### **MEMORANDUM**

Subject: RZ 25-05 & SLUP 25-04 – 84 Perimeter Center East, Parcel ID#18 347 01 013

The applicant, JSJ Perimeter LLC, requests a modification of the zoning and special land use permit conditions of cases RZ 23-02 & SLUP 23-03, to modify existing zoning conditions, update the site plan, and a new special land use permit for a drive through.

Figure 2. Most recently approved site plan

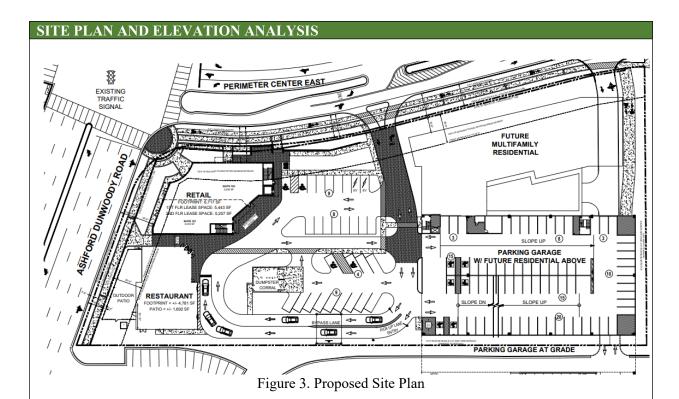
The subsequent case RZ 23-02 & SLUP 23-03 did not alter the site plan but removed a condition related to the timeline in which this development is delivered. The previous zoning actions, RZ 20-03 & SLUP 20-02, included a condition that required the applicant to have an approved Land Disturbance Permit by September 8, 2023. In 2023, the applicant requested to have this condition removed due to the current economic conditions which, at the time, financially impacted the project so that the prescribed deadline could not be feasibly met. This request was approved by the City Council on July 10, 2023.

The current proposed application is a significant departure from the previously approved site plan and exhibits. The applicant requests to amend the site plan and conditions to accommodate the newly proposed drive-through to serve a proposed quick-service restaurant, Portillo's. The site plan also represents a general change in the building sizes and layouts, parking lot design, the location of open space, and the amount of floor area allocation to different uses. The applicant has also provided a Phasing Plan for the proposed development.

EXHIBIT A: Site plan, submitted July 29, 2025.

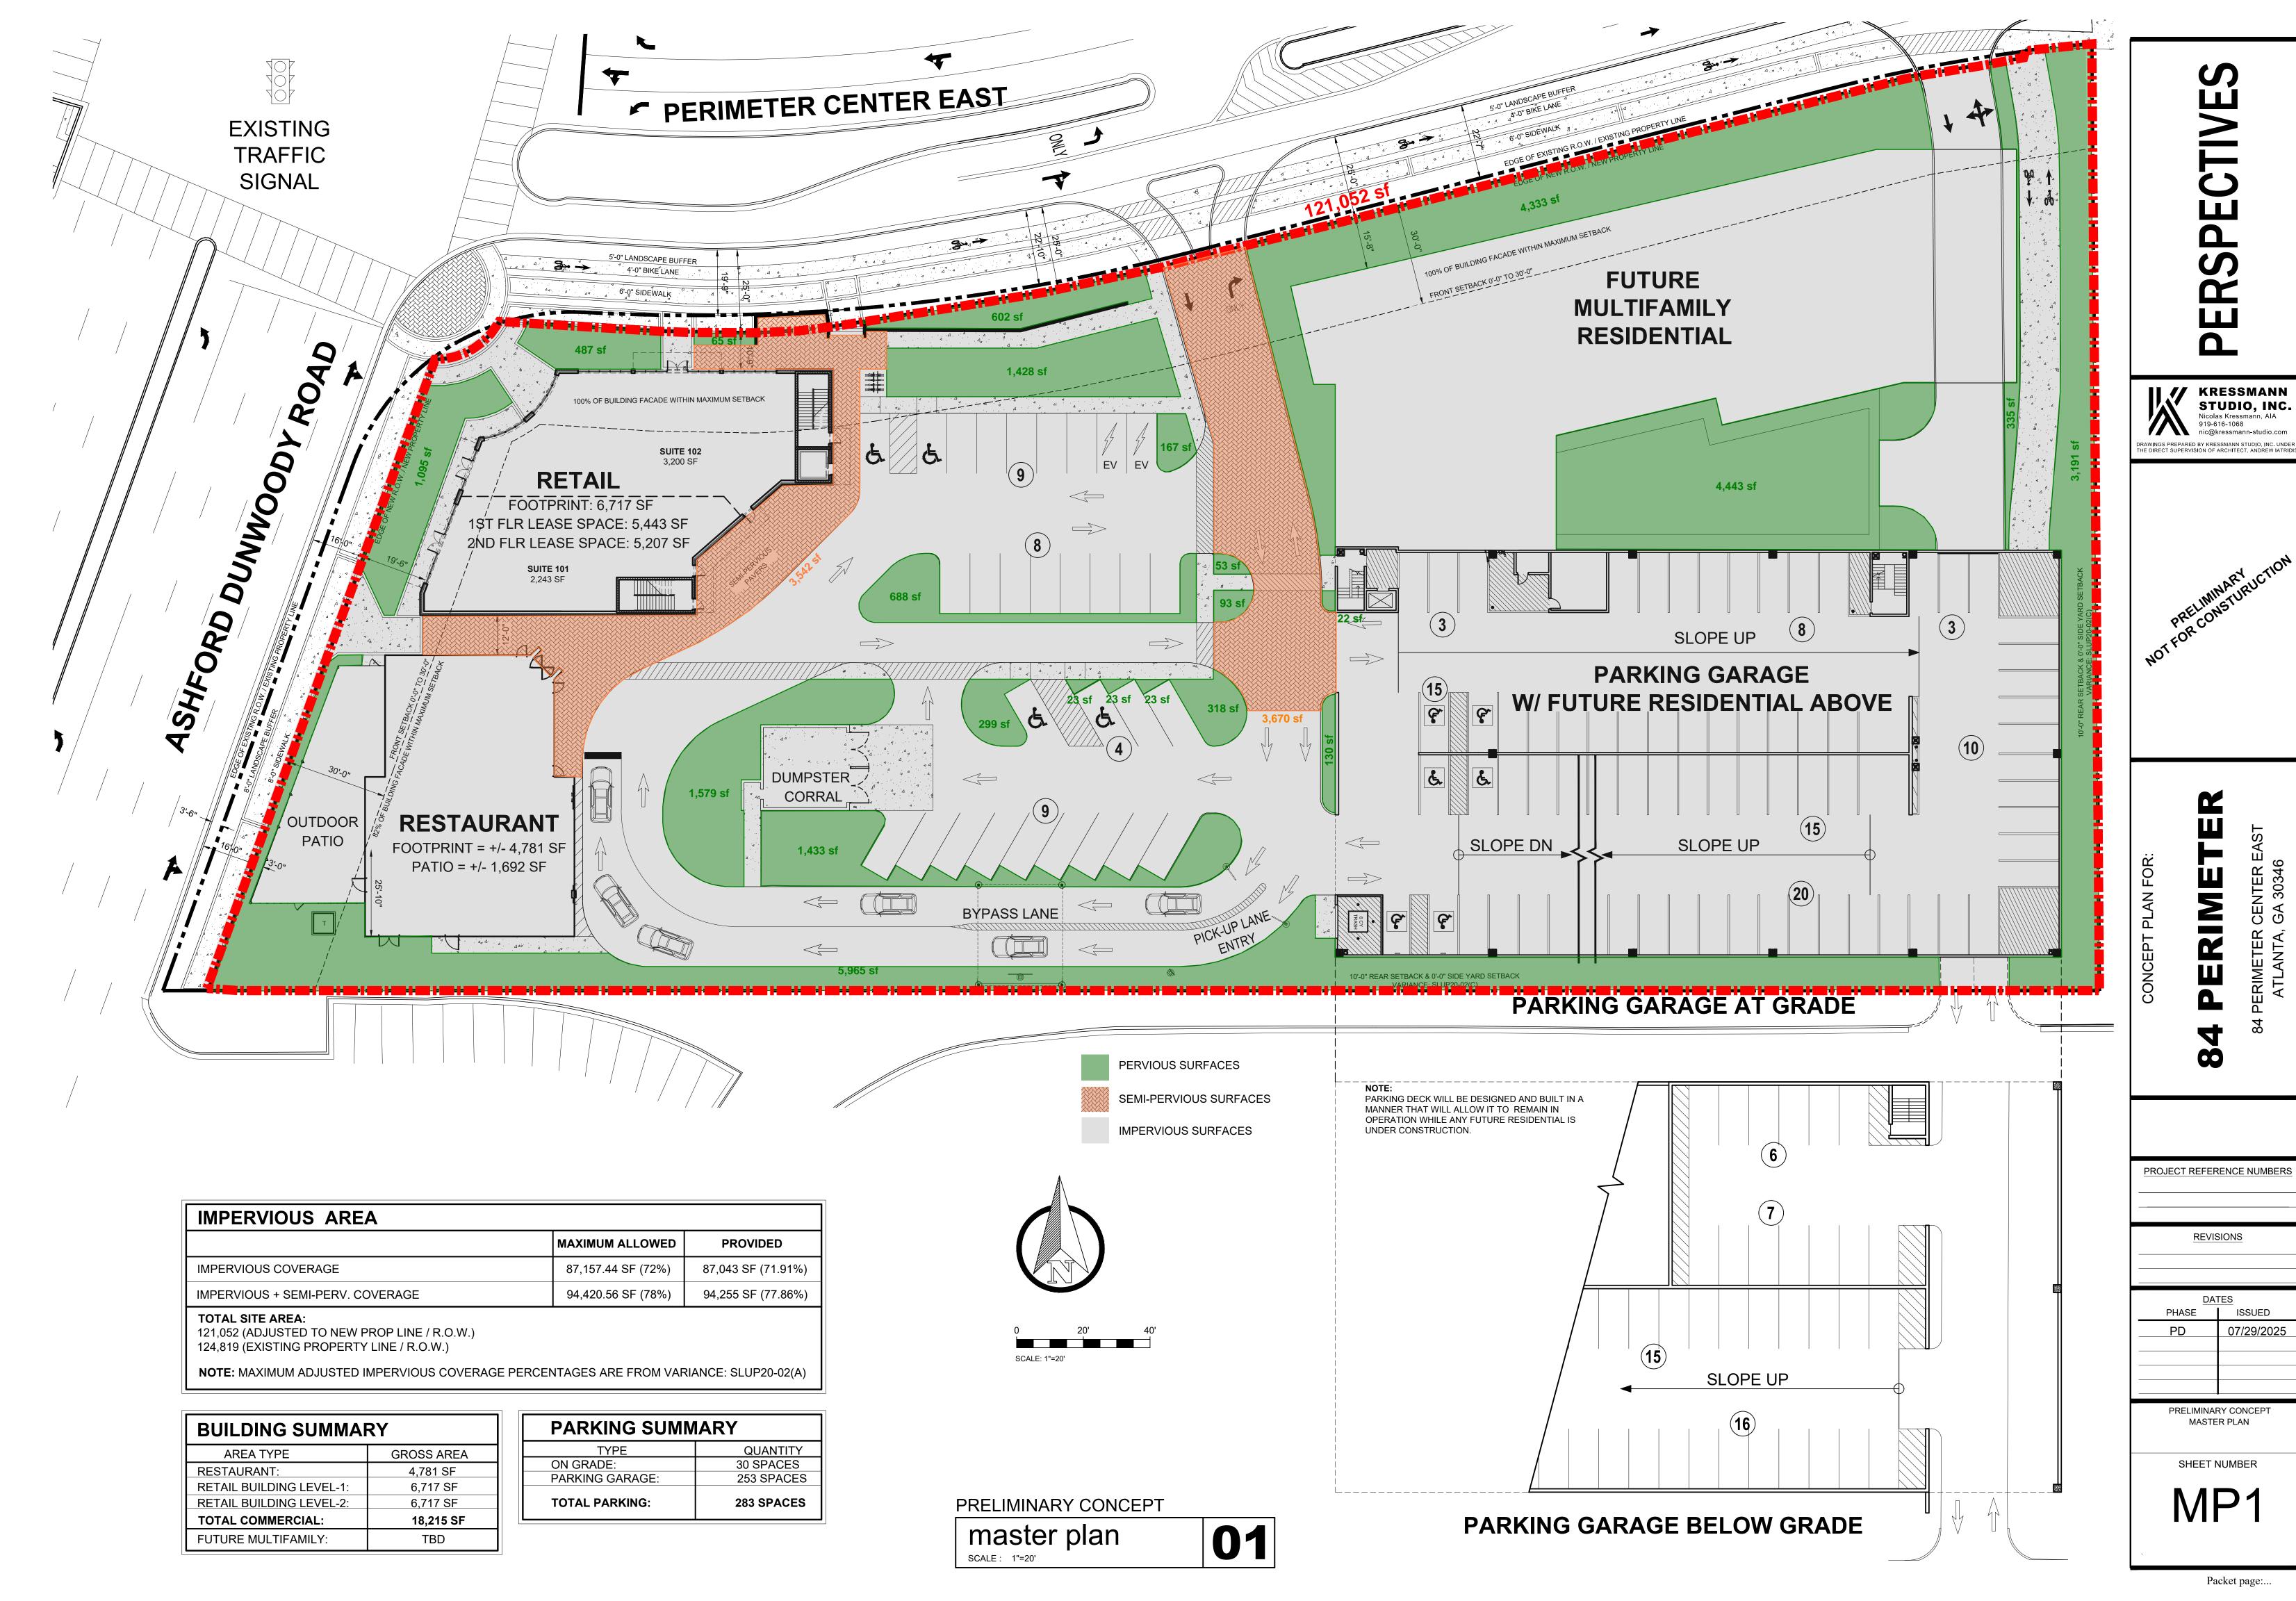
The previous site layout functioned more as one building, with the street-facing retail buildings connected to the residential building via a second-floor plaza. The current site plan creates three separate buildings, each operating independently with shared parking in the parking garage. The access to the site remains the same as the previous iteration; all access to the site is via two driveways from Perimeter Center East, with a future secondary street access to Ravinia Parkway to the south provided along the eastern property line.

PC-2 zoning district but the inclusion of a drive-through is problematic. Staff is also critical of the increased use of surface parking. While the previously approved site plan includes only 13 spaces, the now-submitted plan includes 31 spaces.

The drive-through has a stacking capacity of approximately 12-cars within the dedicated drive-through lane. The proposed drive-through restaurant fronts along Ashford Dunwoody Road, with the drive-through completely to the rear of the building.

- 5. The owner shall develop the site in general conformity with "Exhibit A" with minor changes allowed as defined by Section 27-337(b) or necessary changes to meet conditions of zoning or land development requirements made necessary by actual field conditions at the time of development;
- 6. The owner shall construct the streetscaping in general conformity with "Exhibit B". Any minor variations to the streetscapes made necessary by actual field conditions at the time of development
